# Access Compliance Report

## Public Rights-of-Way

Intersection ID: 10014252	Main Street: PARKWOOD_AV	Cross Street: N/A	Location: NW
ADA ID: 39C4B6914540	Ramp Type: Para	Initial Pass/Fail: Fail	Overall Compliance: No
			Severity Score: 13.75

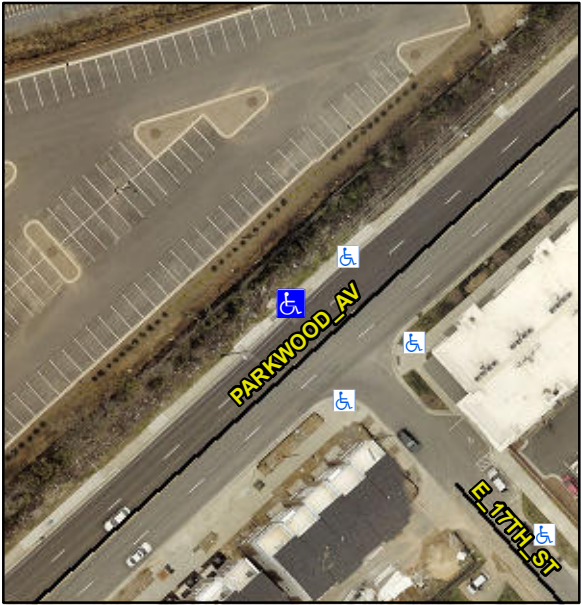
Codes/Mitigation Info/Possible Solution			Field Measurements/Component Compliance		
	Possible Solutions:		<b>Compliance</b>	<b>Description</b>	<b>Data</b>
	<b>Remove &amp; Replace Entire Ramp.</b>		<b>N/A</b>	Ramp Length LT (in)	<b>76.0</b>
			<b>Yes</b>	Ramp Width LT (in)	<b>59.0</b>
			<b>No</b>	Ramp Slope LT (%)	<b>10.9</b>
			<b>Yes</b>	Ramp XSlope LT (%)	<b>1.9</b>
			<b>N/A</b>	Landing Length (in)	<b>N/A</b>
			<b>N/A</b>	Landing Width (in)	<b>N/A</b>
			<b>N/A</b>	Landing Slope (%)	<b>N/A</b>
			<b>N/A</b>	Landing X Slope (%)	<b>N/A</b>
			<b>N/A</b>	Landing Curb? (Y/N)	<b>N/A</b>
<p>Surveyor Notes:</p> <p><b>N/A</b></p> <p>PROW/ADA:</p> <p><b>R304.3.2, R304.5.3</b></p>			<b>N/A</b>	Ramp Slope RT (%)	<b>9.4</b>
			<b>No</b>	Ramp XSlope RT (%)	<b>2.5</b>
			<b>N/A</b>	DWS Provided?	<b>N/A</b>
			<b>N/A</b>	DWS Contrast?	<b>N/A</b>
			<b>N/A</b>	DWS Length (in)	<b>N/A</b>
			<b>N/A</b>	DWS Full Width?	<b>N/A</b>

<b>N/A</b>	DWS Offset (in)	<b>N/A</b>
			<b>N/A</b>	Gutter Slope (%)	<b>N/A</b>
			<b>N/A</b>	Gutter X Slope (%)	<b>N/A</b>
			<b>N/A</b>	Painted X Walk1?	<b>No</b>
			<b>N/A</b>	X Walk 1 Direction	<b>To SE</b>
			<b>N/A</b>	X Walk 1 Width (in)	<b>N/A</b>
				X Walk 1 Slope (%)	<b>2.4</b>
				X Walk 1 X Slope (%)	<b>0.1</b>
			<b>N/A</b>	Ramp inside XWalk1?	<b>N/A</b>
			<b>N/A</b>	Road Slope (%)	<b>N/A</b>
			<b>N/A</b>	Road X Slope (%)	<b>N/A</b>
			<b>N/A</b>	Any Obstructions?	<b>N/A</b>
				Obstruction Type	
			<b>N/A</b>	Storm Grate/Utility Hazard?	<b>N/A</b>
Total Cost:		<b>\$ 1600.00</b>		Storm Grate/Utility Type	
			<b>N/A</b>	Surface Condition? (G/P)	<b>Good</b>
			<b>N/A</b>	Curb Slope (%)	<b>9.8</b>
